CONWAY
HISTORIC DISTRICT COMMISSION
STAFF REPORT

5:30 pm • December 19, 2019 • City Hall

HISTORIC DISTRICT COMMISSION

FRONT ELEVATION

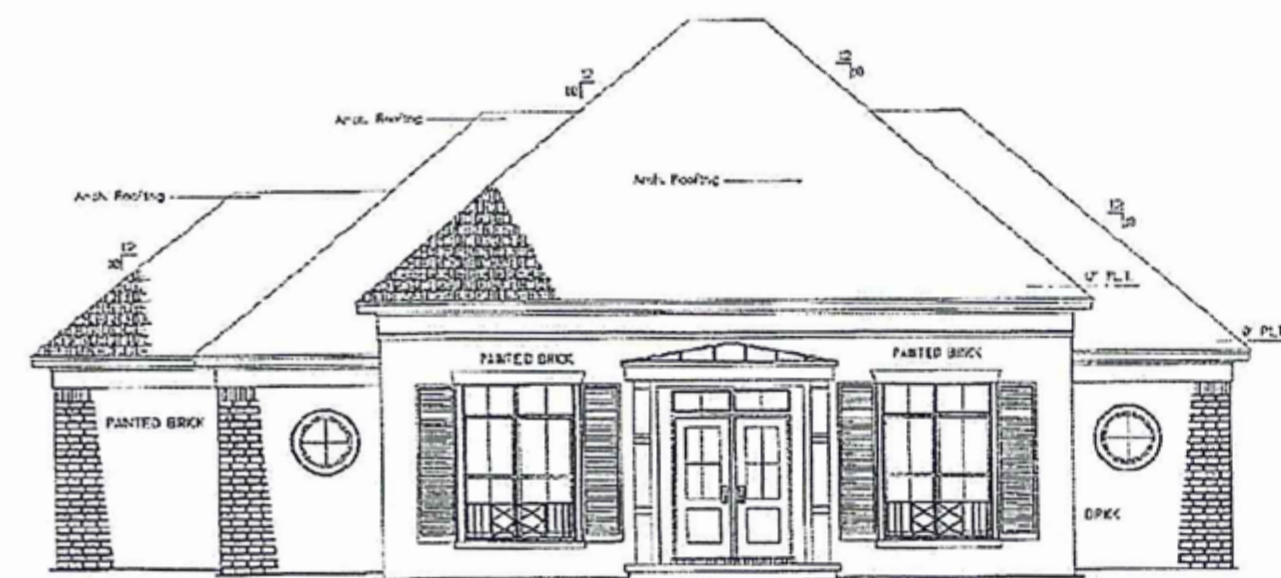
The proposed structure will contain far fewer windows openings compared to surrounding structures. Window openings are highly prominent for all surrounding structures. Given the tiered nature of the front façade, the blank façades of the home's sides will be more visible to the street. Additionally, the towering nature of the roof line contributes to the feeling of a lack of windows on the structure.

Recommend requiring at least 30% of the front and side façades be composed of window openings. Recommend requiring a more substantial (wider) front façade at the very front of the structure to reduce the complexity of the roof form.

The roof form is more highly complicated than typically seen within the surrounding area or for the style. The width of the structure to the roof pitch gives the roof a towering feel. A wider front façade at the very front of the structure as well as dormers above the two front windows could reduce this towering character. The applicant is proposing architectural shingles which should be required. Recommend requiring an altered roof form that reduces its towering nature with architectural shingles required.

2. Require at least 30% of the front and side facades be composed of window openings.
3. Require a more substantial (wider) front façade at the very front of the structure to reduce the complexity of the roof form.

7. Require an altered roof form that reduces the roof's towering nature with architectural shingles required.
8. HVAC equipment be placed in a manner to minimize its visibility from the street.

Proposed west elevation

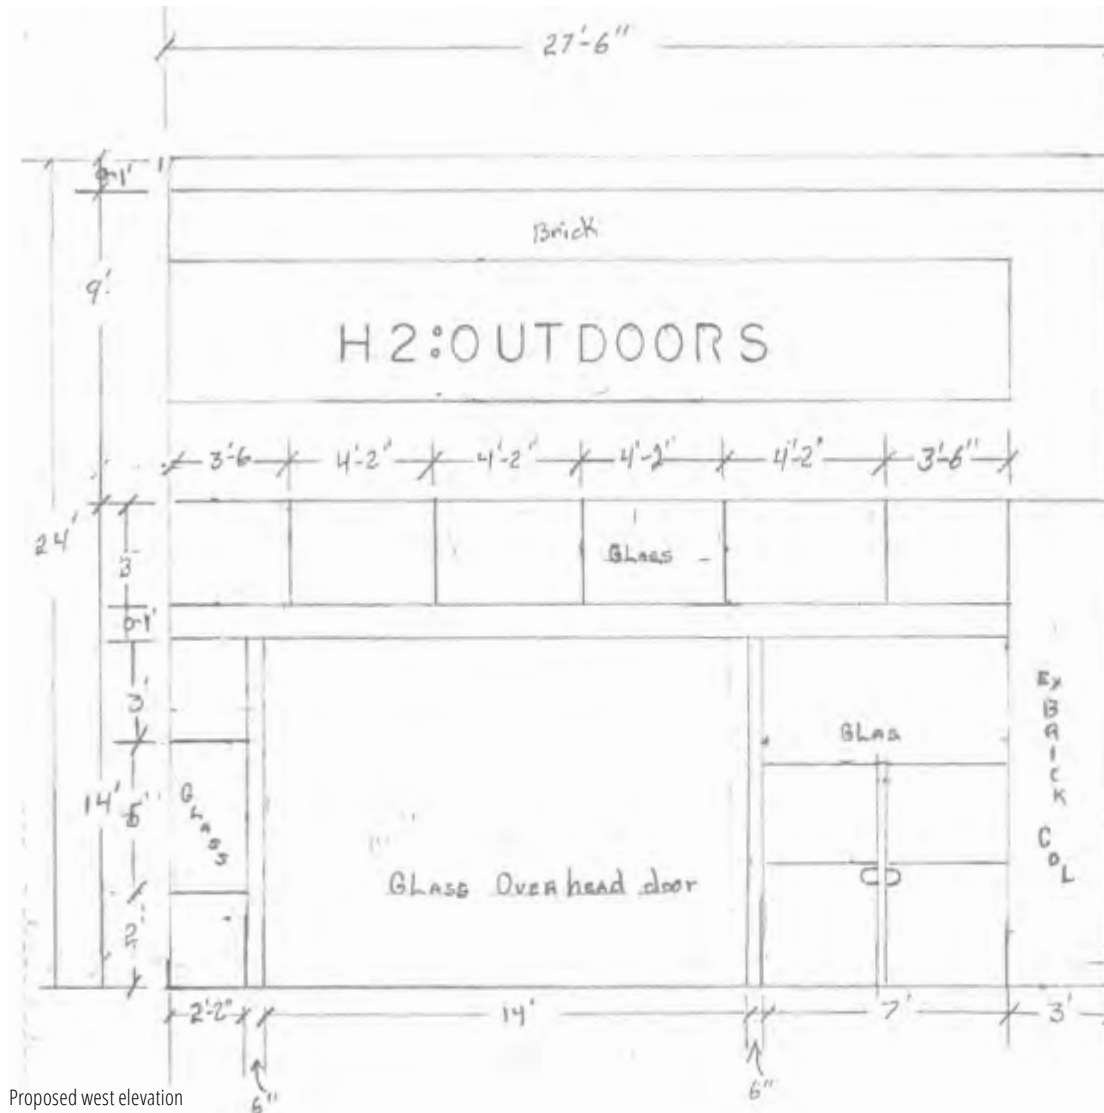
The application meets this requirement. The entire area proposed to be enclosed will be replaced by windows and entries.

The applicant is not proposing frosted or tinted glass on any windows. As proposed the applicant will use dark bronze storefront framing and clear glass.

1. The work shall be completed in conformance with the submitted plans including all glass storefront and entryways.
2. All glass shall be transparent.
3. A brick "low wall" shall be provided at the rear parking area along the Main St frontage for screening purposes.
4. Tinted glass is prohibited.
5. No signage is approved as part of this request.
